Project	IEEE 802.16 Broadband Wireless Access Working Group < http://ieee802.org/16 >	
Title	MRS Handover in Tunneling Case	
Date Submitted	2007-05-08	
Source(s)	David Comstock, John Lee, Guohui Zou, Peng Yan Huawei Technologies No.98, Lane91, Eshan Road, Shanghai, P.R.C	{ dcomstock , john_lee , ghzhou , peng.yan }@huawei.com Voice: +1 858 735 9382
Re:	IEEE 802.16j-07/007r2: "Call for Technical comments and contributions regarding IEEE Project P802.16j"	
Abstract	This document presents a MRS handover mechanism in tunneling case.	
Purpose	Add proposed spec changes in P802.16j Baseline Document (IEEE 802.16j-06/026r2)	
Notice	This document has been prepared to assist IEEE 802.16. It is offered as a basis for discussion and is not binding on the contributing individual(s) or organization(s). The material in this document is subject to change in form and content after further study. The contributor(s) reserve(s) the right to add, amend or withdraw material contained herein.

MRS Handover in Tunneling Case

David Comstock, John Lee, Zou Guohui, Peng Yan
Huawei Technologies Co. Ltd

Figure 1 MRS Handover procedure

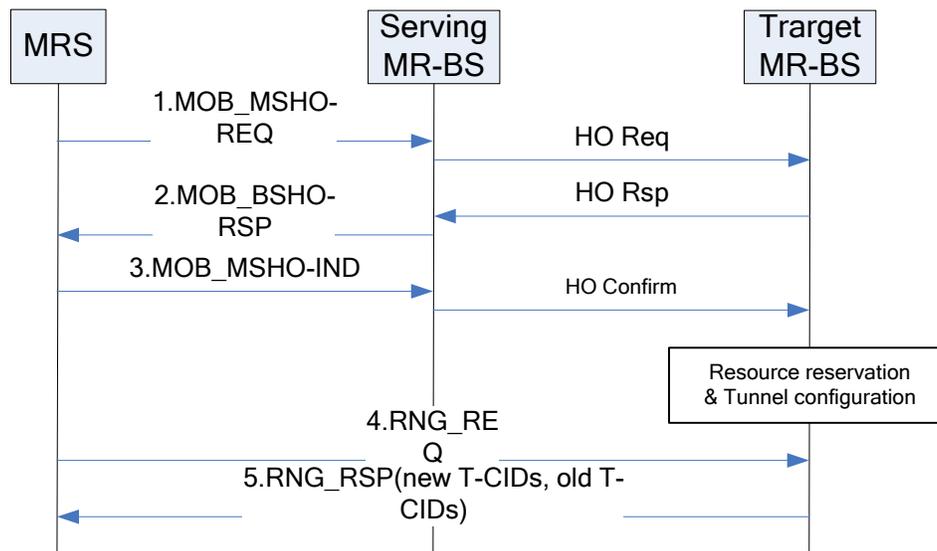
1. MRS sends MOB_MSHO-REQ message to the serving MR-BS for handover initialization. The serving MR-BS may send MRS info and tunnels info to the target MR-BS over the backbone for handover preparation.

MRS info includes MRS MAC address. Tunnel info includes CID and QoS parameters of a tunnel, SFIDs and CIDs of the MSs who attach to the MRS in tunneling case.

2. After receiving the response from target MR-BS, the serving MR-BS responds with MOB_BSHO-RSP message.
3. The MRS uses MOB_HO-IND to commit handover. Upon receipt of MOB_HO-IND, the serving MR-BS sends HO-confirm, which inform the target MR-BS to reserve resource and configure tunnels.
4. The MRS performs network re-entry by sending RNG-REQ to the target MR-BS.
5. The MR-BS assigns new tunnel CIDs, and sends them to MRS in RNG-RSP together with the old tunnel CIDs.
